Pentium® II Processor Specification Update

Release Date: August 1999

Order Number: 243337-029

The Pentium® II processor may contain design defects or errors known as errata which may cause the product to deviate from published specifications. Current characterized errata are documented in this Specification Update.

Figure 1. UP Dual Ended Termination (DET)

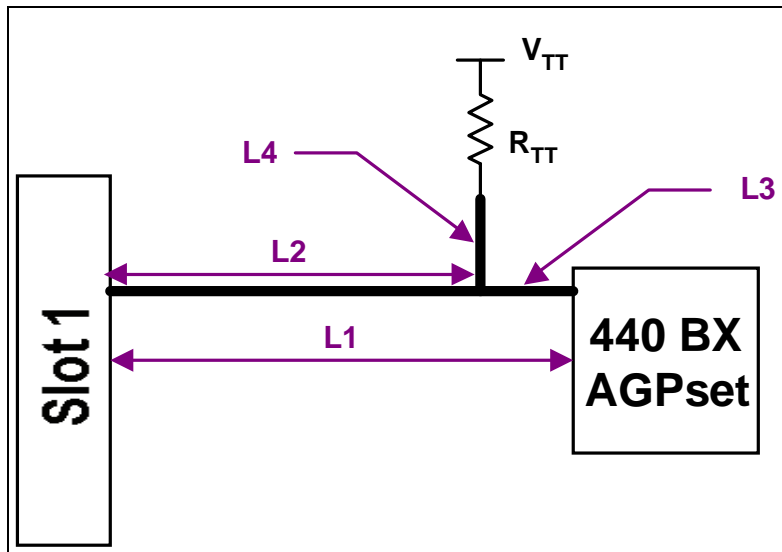
IMPLICATION: This violation of the bus exchange protocol when using a reduced arbitration latency may cause a system-level setup timing violation on the address, address parity, request command, or request parity signals on the system bus. This may result in a system hang or assertion of the AERR# signal, causing an attempted corrective action or shutdown of the system, as the system hardware and software dictate. The possibility of failure due to the contention caused by this erratum may be increased due to the processor's internal active pull-up of these signals on the clock after the signals are no longer being driven by the processor.

WORKAROUND: If the chipset and third party agents used with the Pentium II processor do not optimize their arbitration latency as described above, no action is required. For the 66 MHz Pentium II processor, no action is required. If agents that have implemented this optimization, by following the *100 MHz GTL+ Layout Guidelines for the Pentium® II Processor* and *Intel 440BX AGPset* for UP-SET (single-ended termination) and DP with both processors installed, no action is required. The following two cases are additional guidelines for UP-DET (dual-ended termination) and DP-DET with only one processor populated.

For UP-DET topologies (see Figure 1), the trace length L1 must be between 1.5" to 4.5" while using a 56Ω termination resistor.
